FINAL DRAINAGE REPORT

LOT 1 & LOT 2 CROSSROADS MIXED USE
FILING NO. 2
EL PASO COUNTY, COLORADO

APRIL 2023

Project #18-005
PCD Filing No.: PPR2311

LOT 1 & LOT 2 CROSSROADS MIXED USE
FILING NO. 2
EXISTING CONDITIONS DRAINAGE MAP

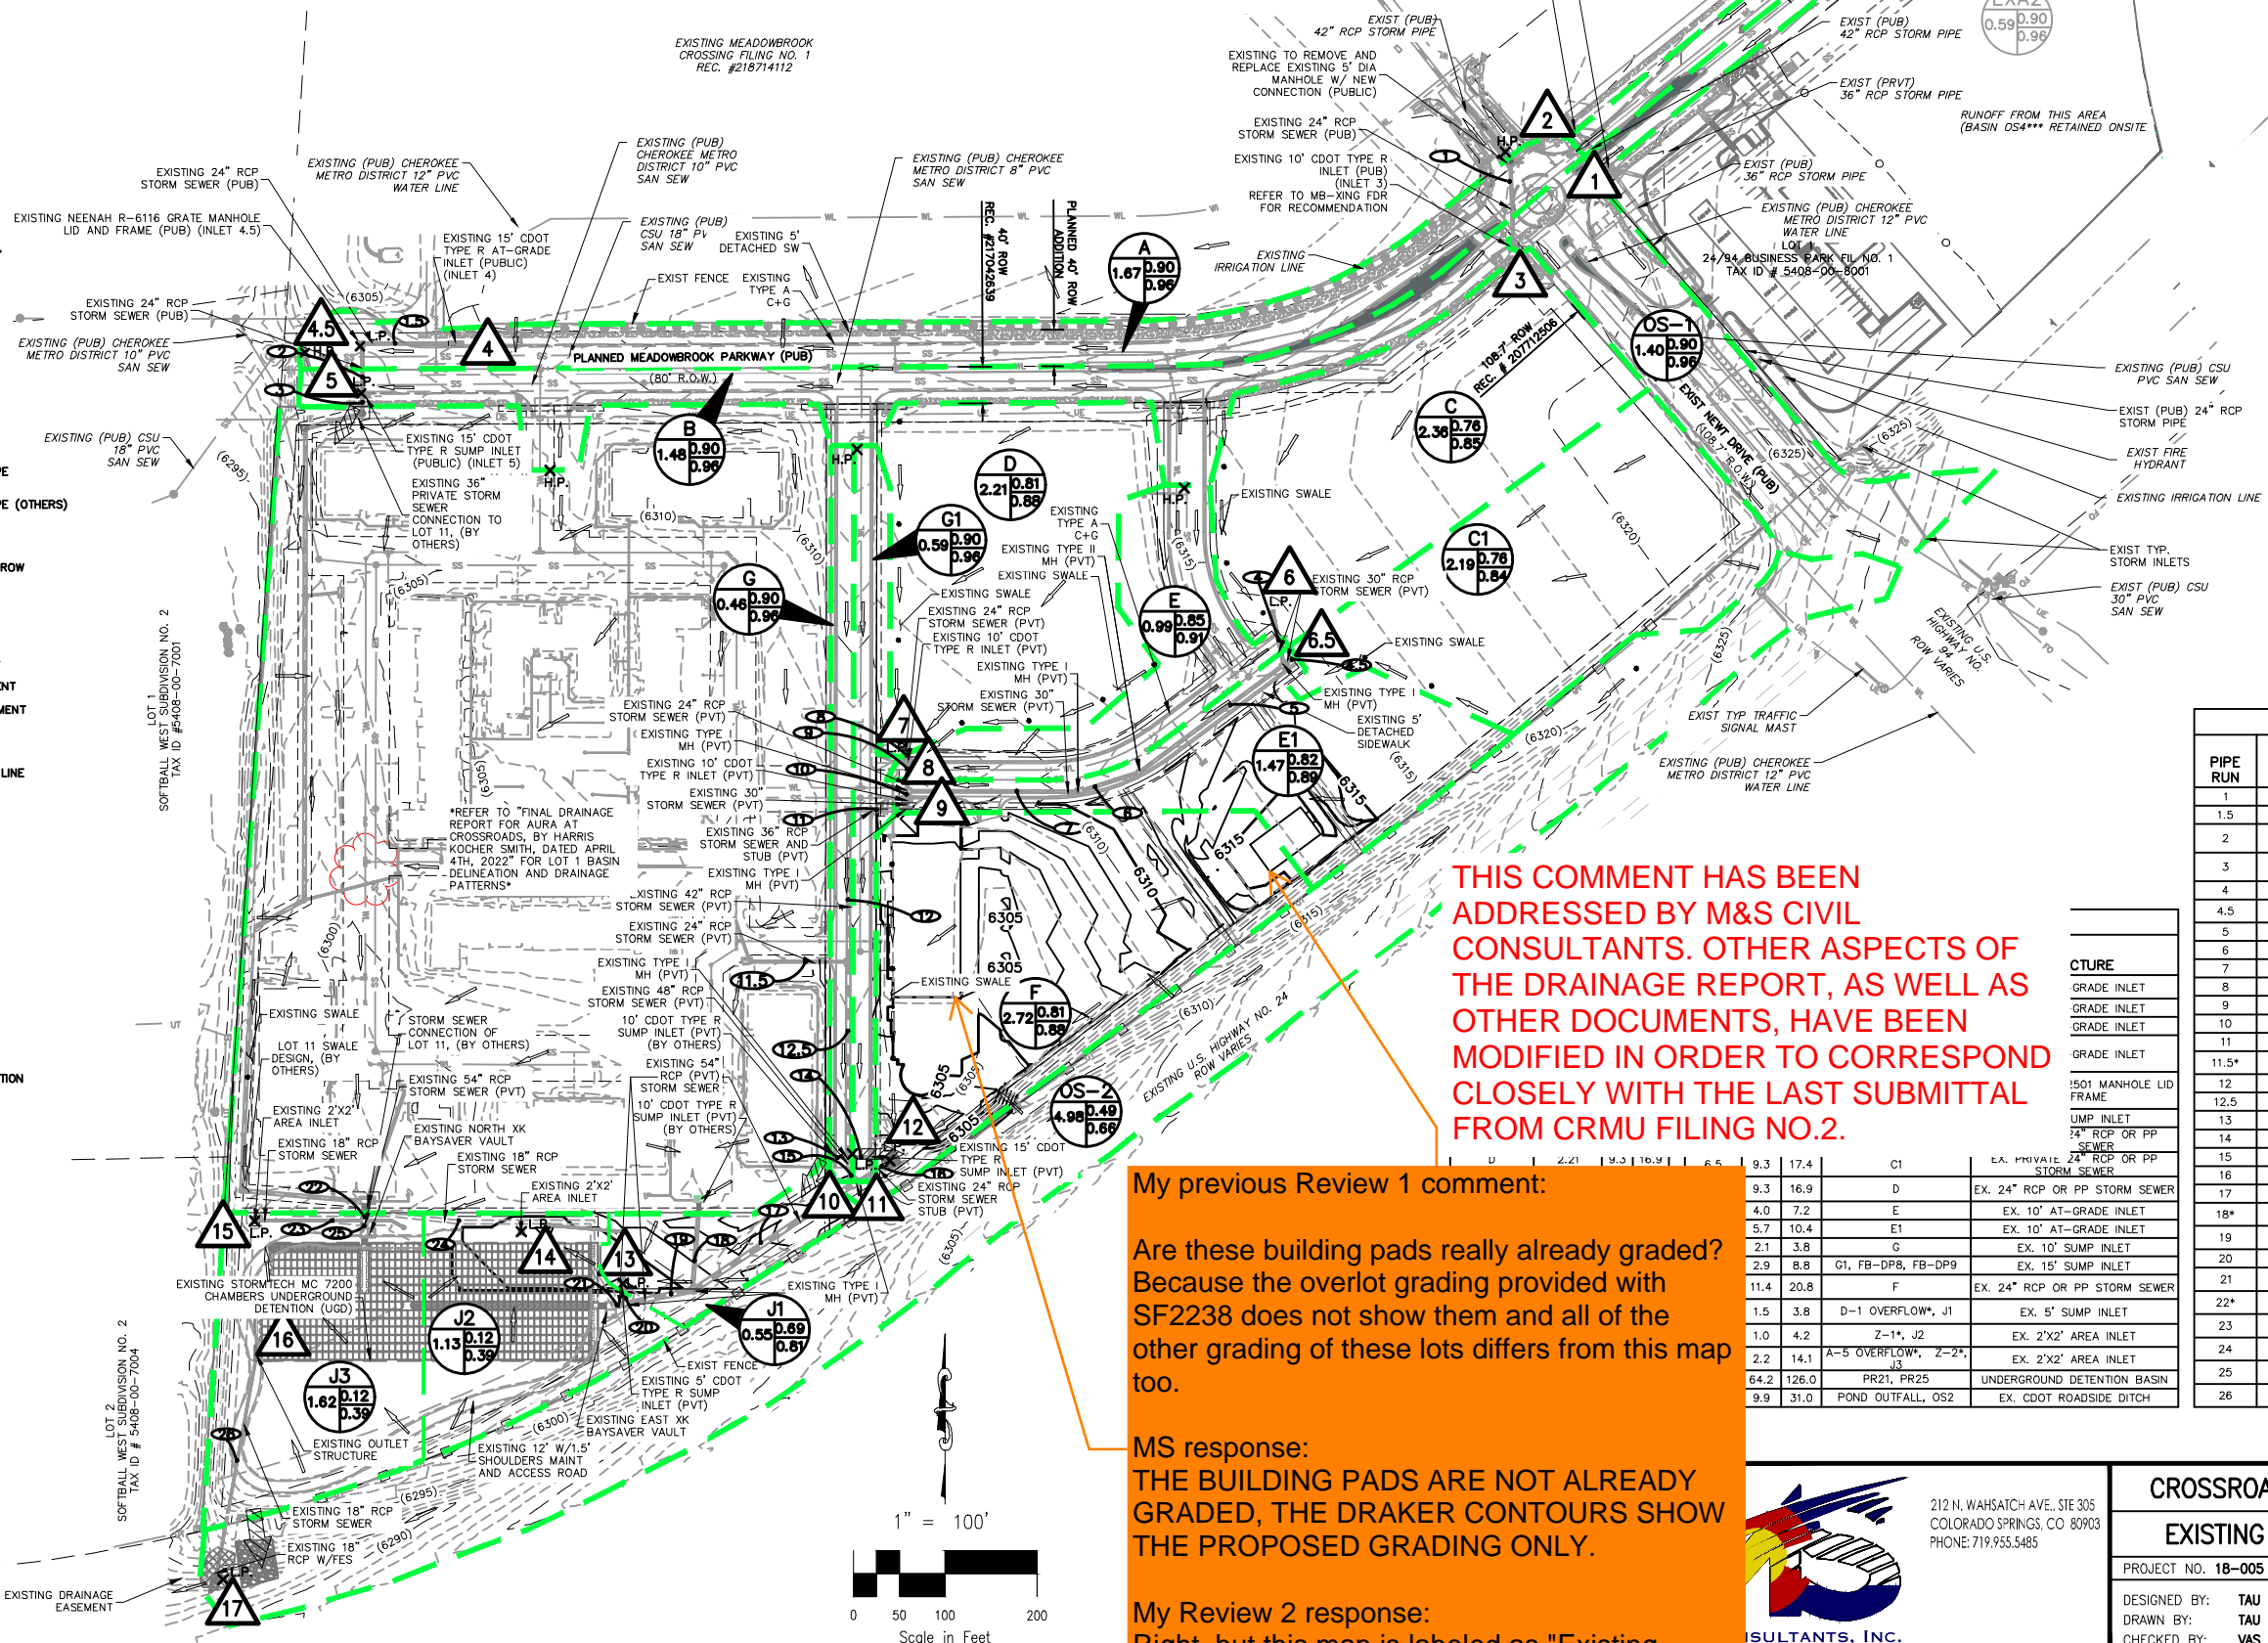
My previous Review 1 comment:

Are these building pads really already graded?
Because the overlot grading provided with
SF2238 does not show them and all of the
other grading of these lots differs from this map
too.

My Review 2 response:
Right, but this map is labeled as "Existing
Conditions Drainage Map" so remove any
proposed grading.

MS response:
THE BUILDING PADS ARE NOT ALREADY
GRADED, THE DRAKER CONTOURS SHOW
THE PROPOSED GRADING ONLY.

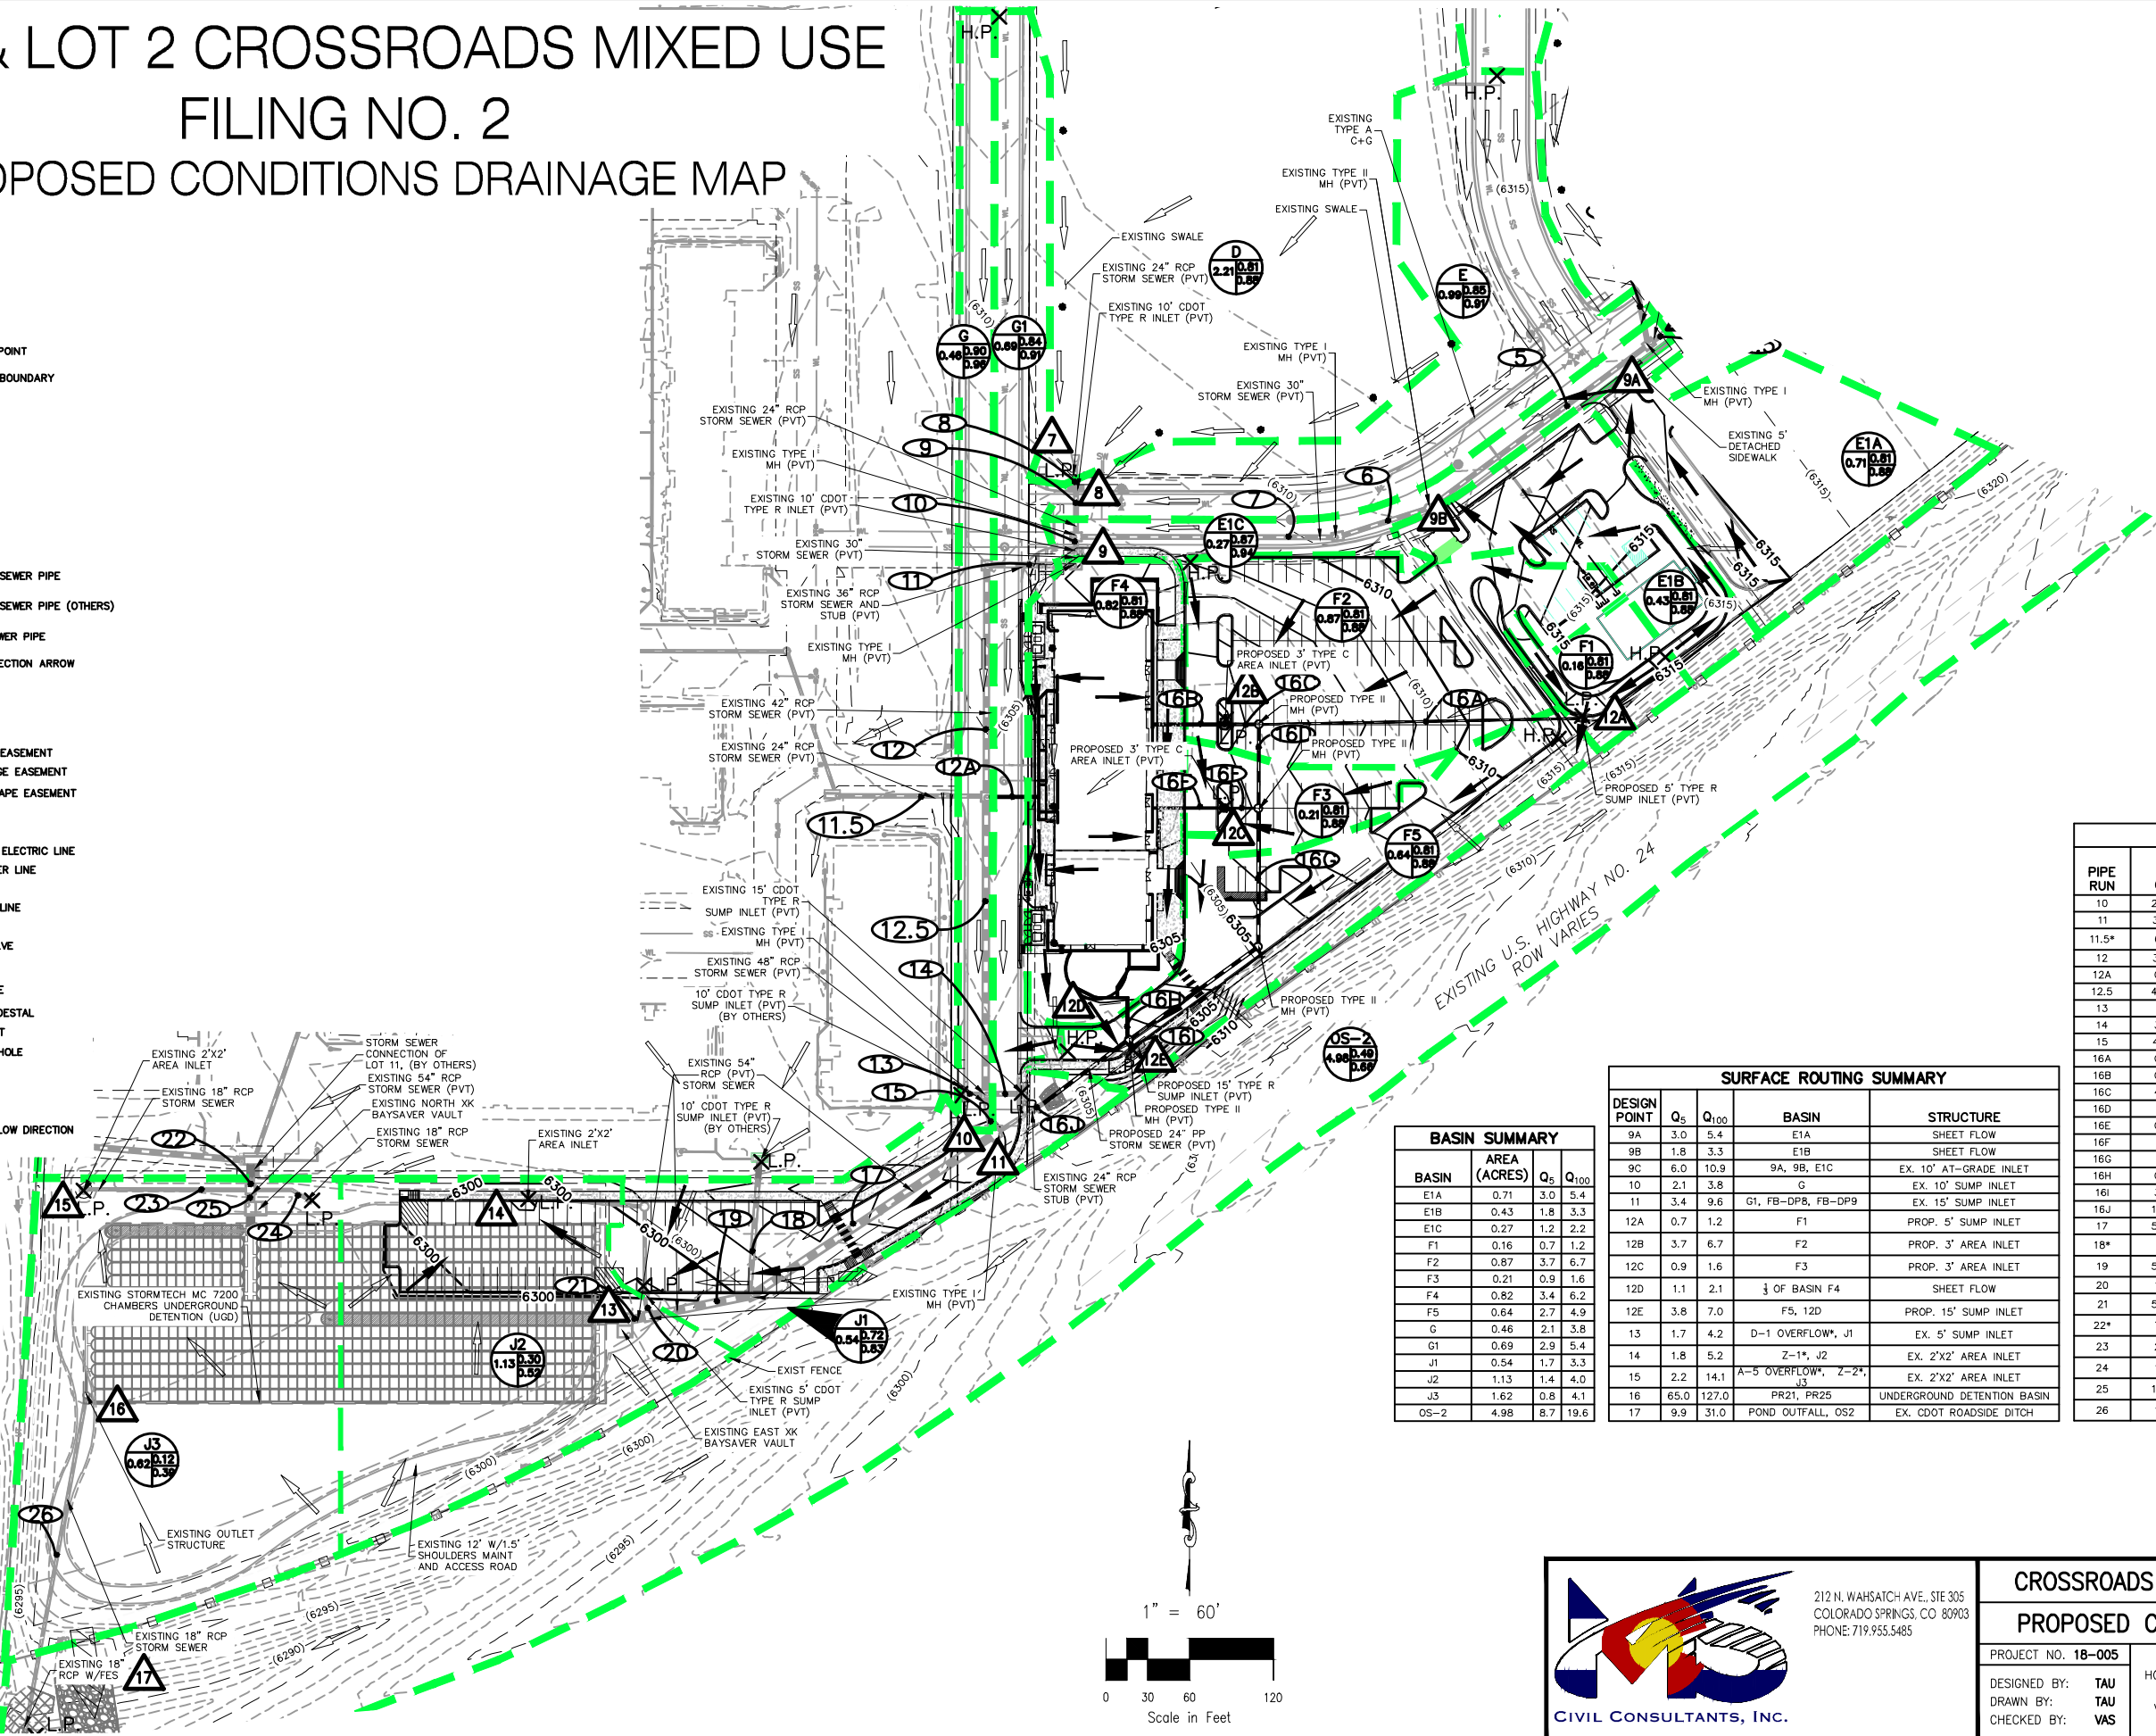
My previous Review 1 comment:

Are these building pads really already graded?
Because the overlot grading provided with SF2238 does not show them and all of the other grading of these lots differs from this map too.

My Review 2 response:

Right, but this map is labeled as "Existing Conditions Drainage Map" so remove any proposed grading.

MS response:

THE BUILDING PADS ARE NOT ALREADY GRADED, THE DRAKER CONTOURS SHOW THE PROPOSED GRADING ONLY.
